Mayberry, Colorado Springs

Filing No. 3

Construction Drawings

MAYBERRY, COLORADO SPRINGS - FILING NO. 3

GALVESTON TERRACE PLAN & PROFILE (STA: 10+00 TO STA: 17+91.77)

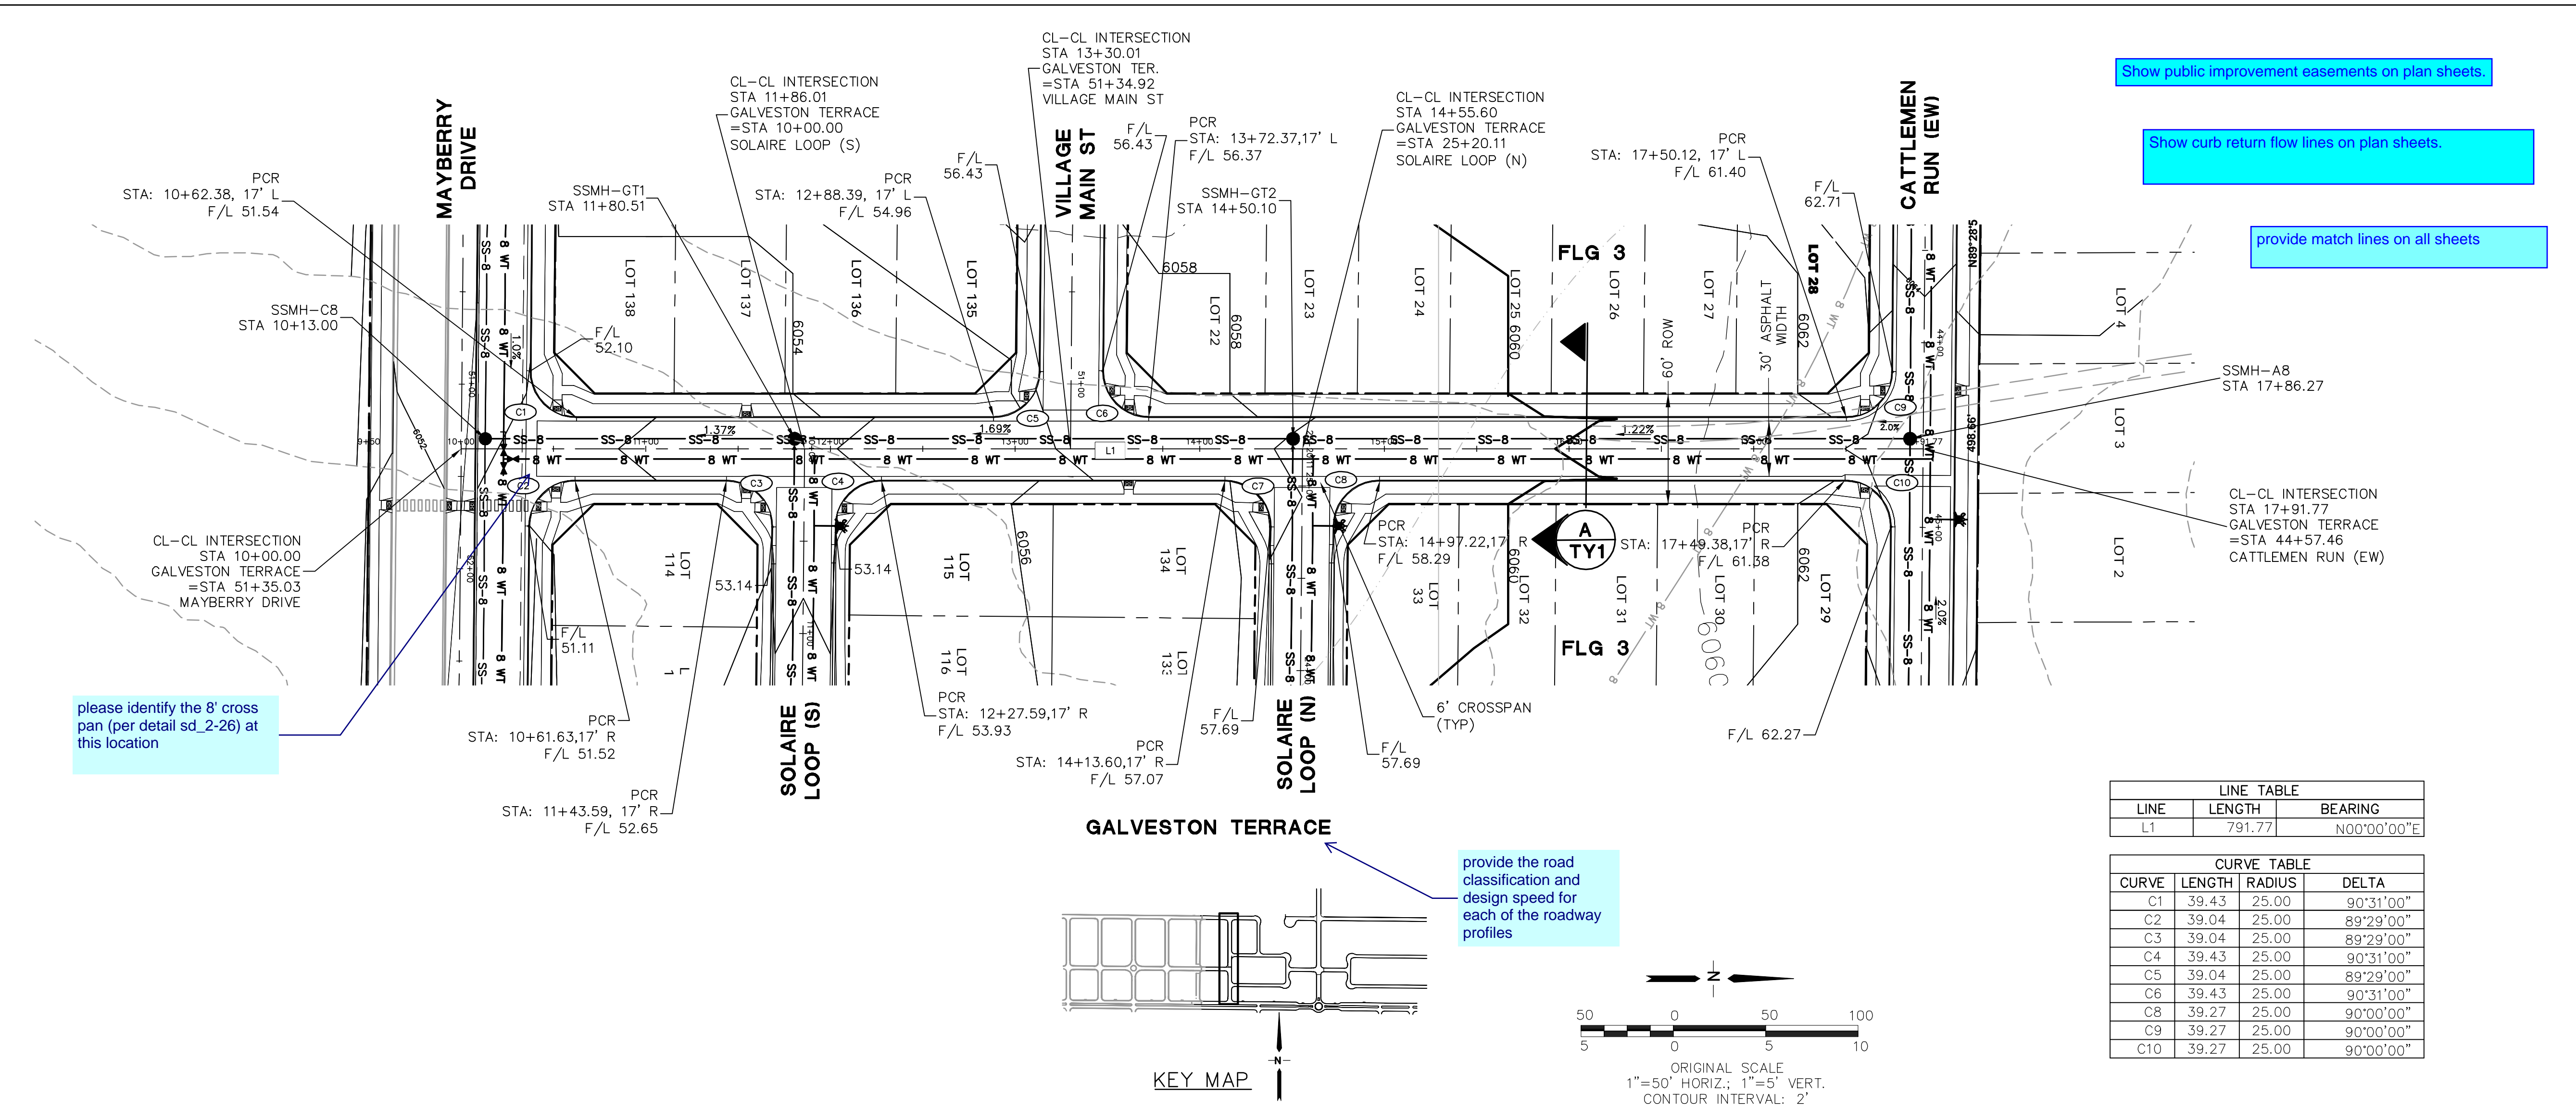
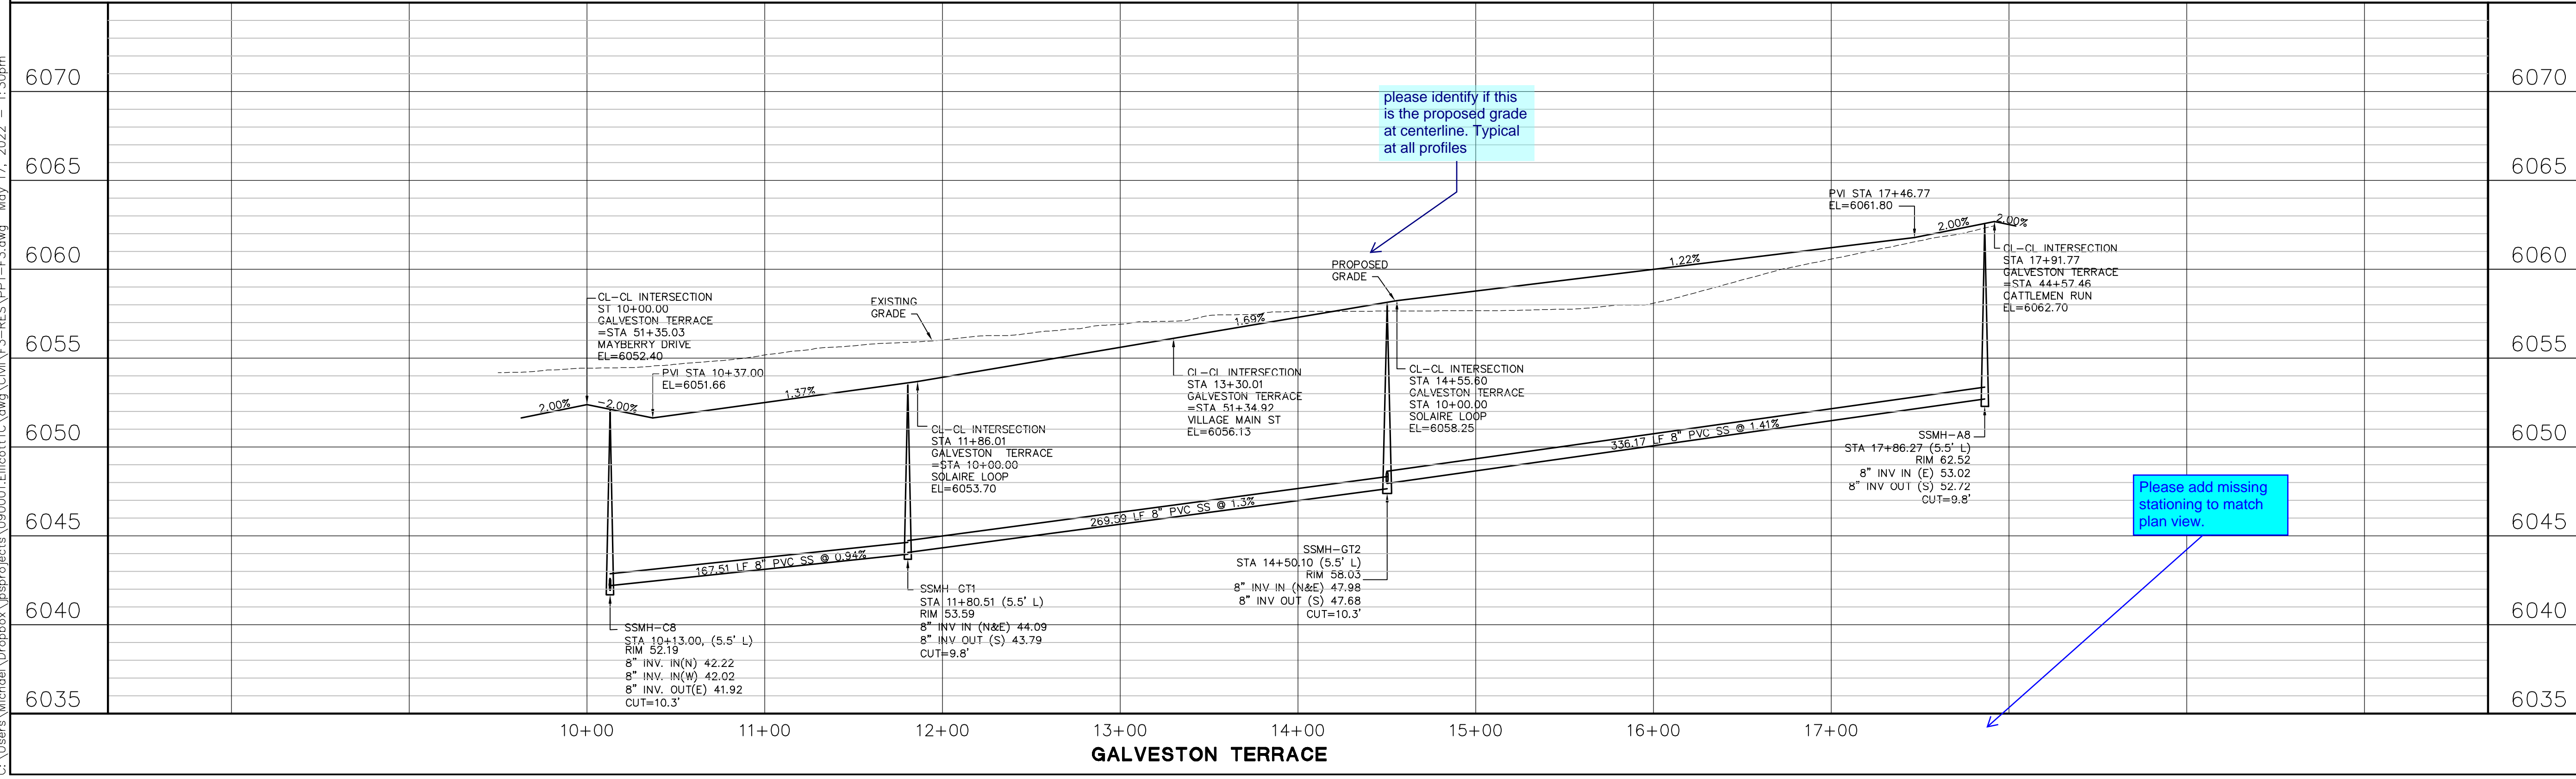
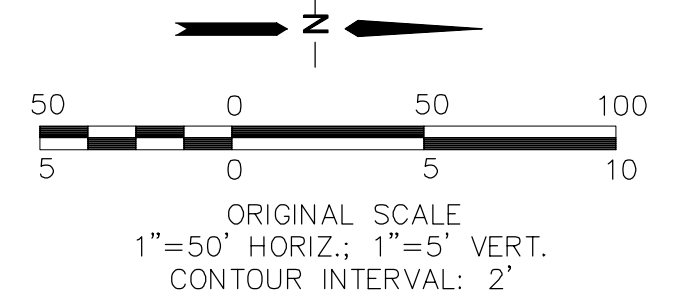
Show public improvement easements on plan sheets.
Show curb return flow lines on plan sheets.
provide match lines on all sheets

please identify the 8' cross pan (per detail sd_2-26) at this location

provide the road classification and design speed for each of the roadway profiles

Please add missing stationing to match plan view.

please identify if this is the proposed grade at centerline. Typical at all profiles

UNION PACIFIC WAY PLAN & PROFILE (STA: 10+00 TO STA: 19+34.17)

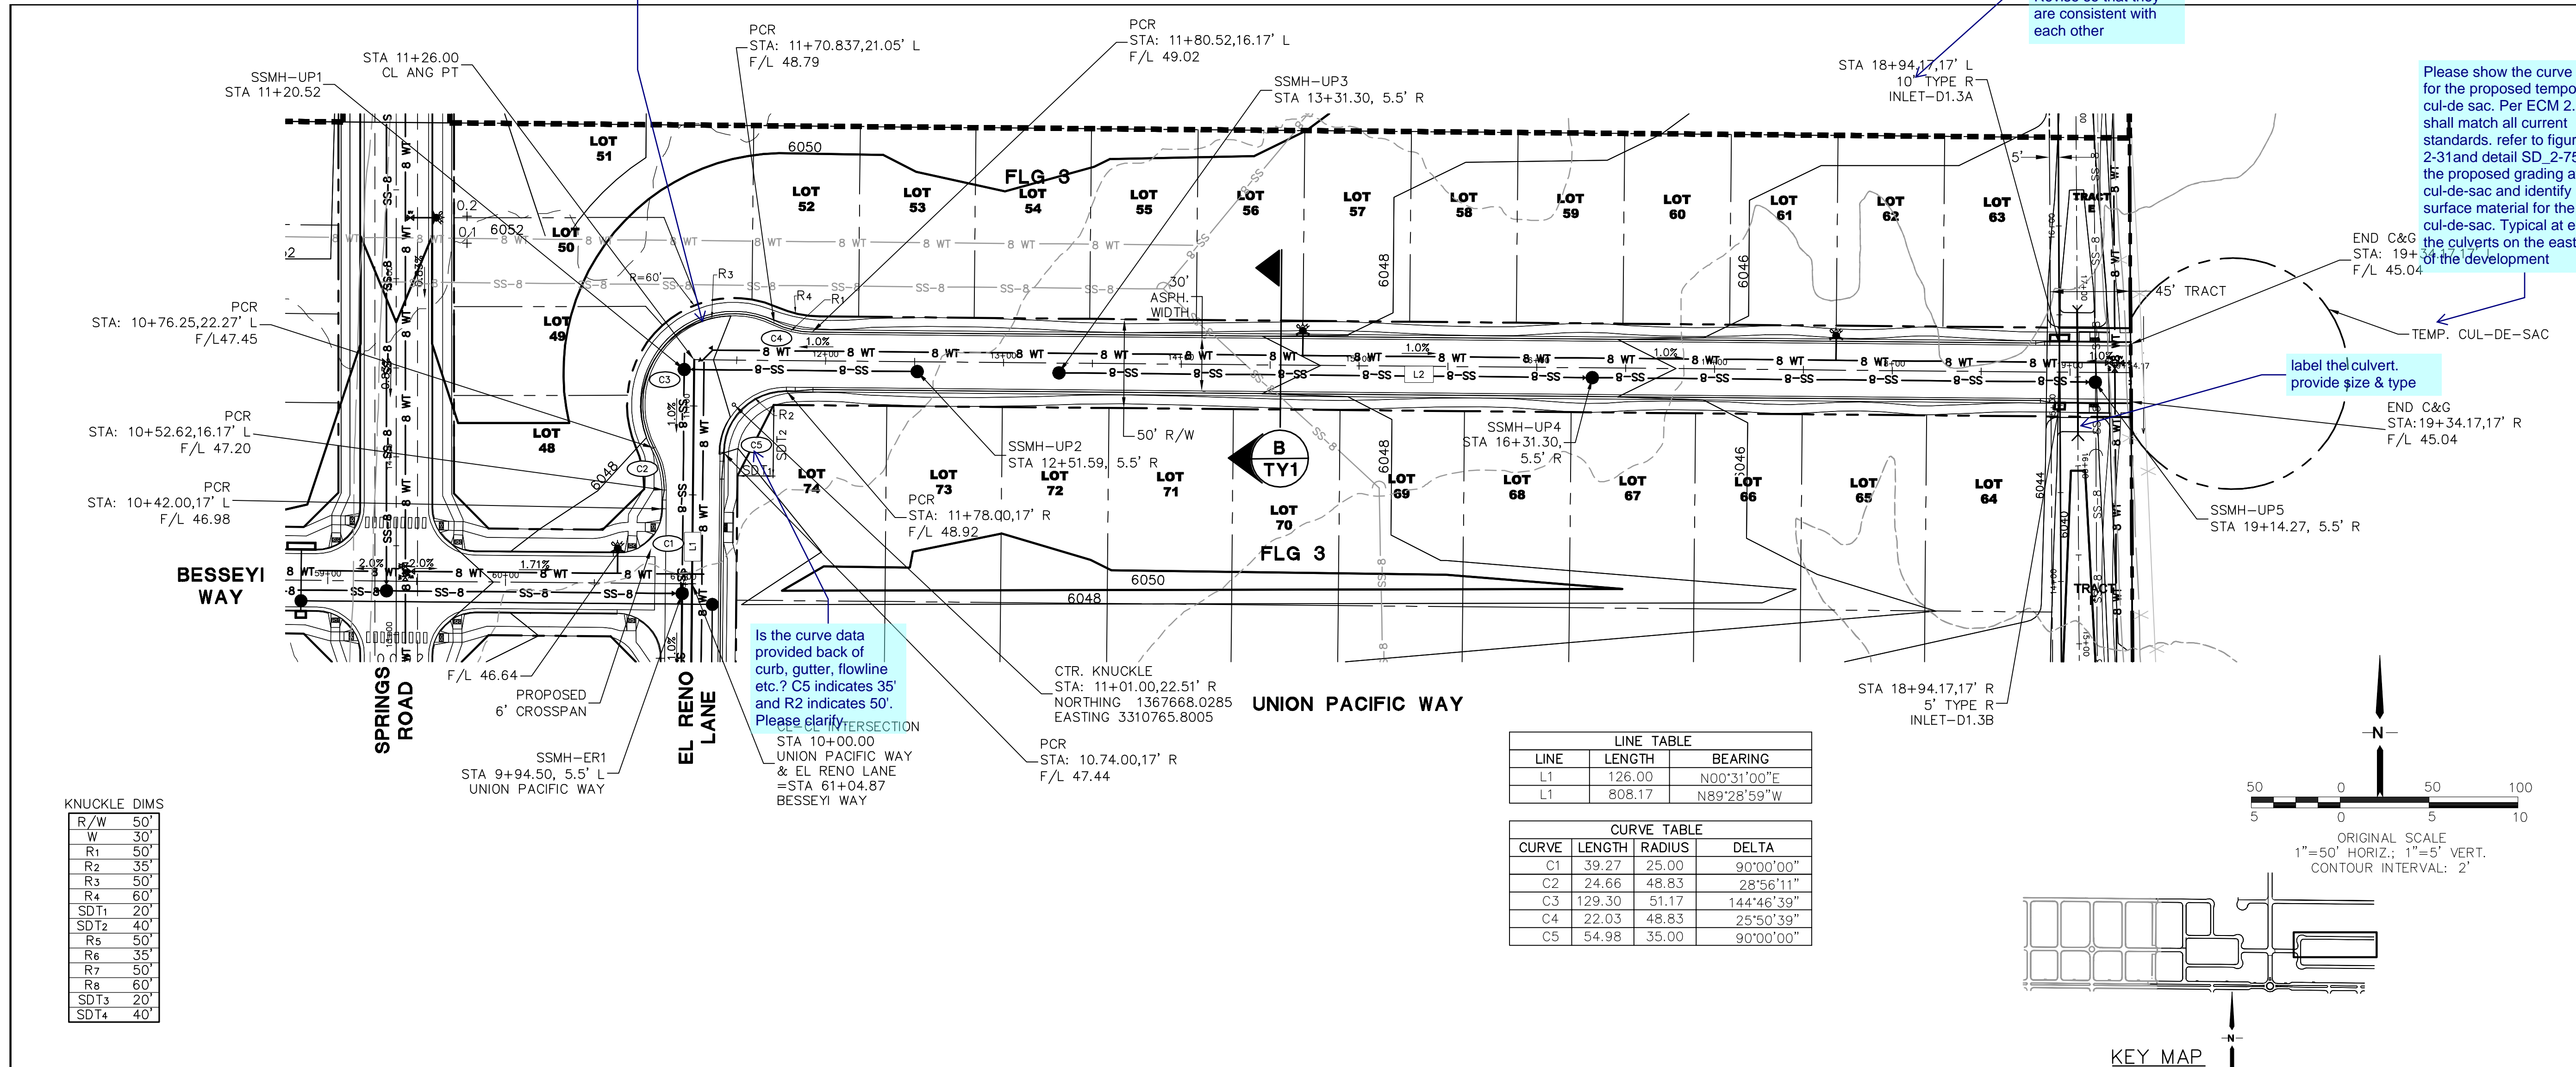
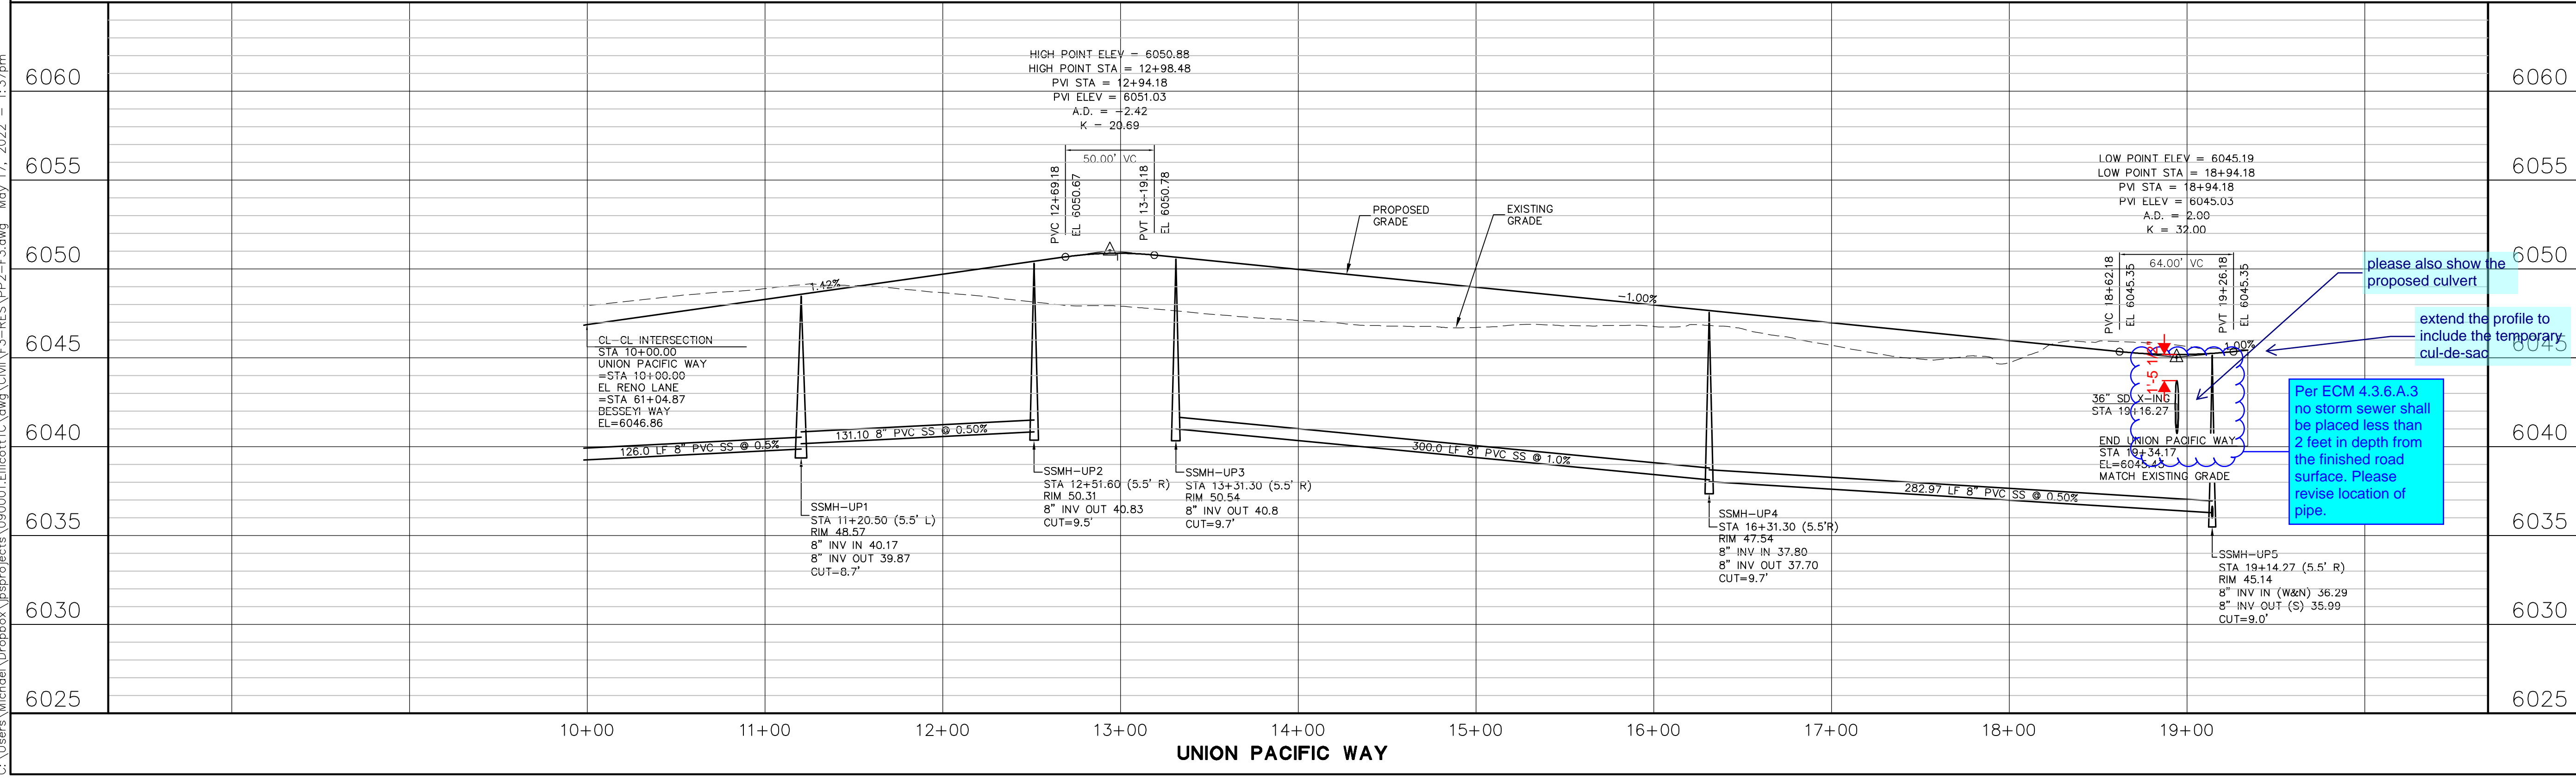
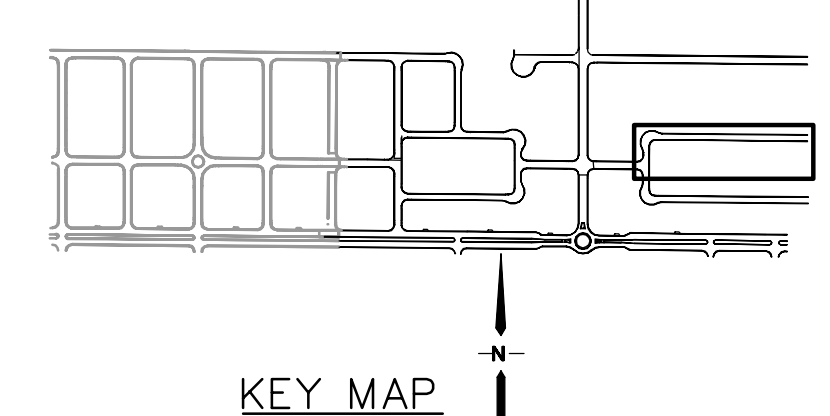
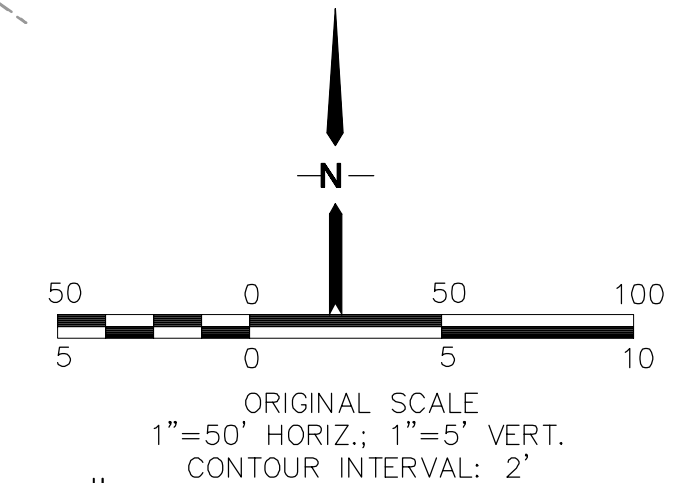
Provide profile at knuckle, typical for all proposed knuckles

5' inlet is indicated on the drainage plan. Revise so that they are consistent with each other

Please show the curve data for the proposed temporary cul-de-sac. Per ECM 2.3.8.C.3 shall match all current standards, refer to figure 2-31 and detail SD 2-75. Show the proposed grading at the cul-de-sac and identify paved surface material for the cul-de-sac. Typical at each of the culverts on the east side of the development

Is the curve data provided back of curb, gutter, flowline etc.? C5 indicates 35' and R2 indicates 50'. Please clarify

label the culvert, provide size & type

please also show the proposed culvert

Per ECM 4.3.6.A.3 no storm sewer shall be placed less than 2 feet in depth from the finished road surface. Please revise location of pipe.
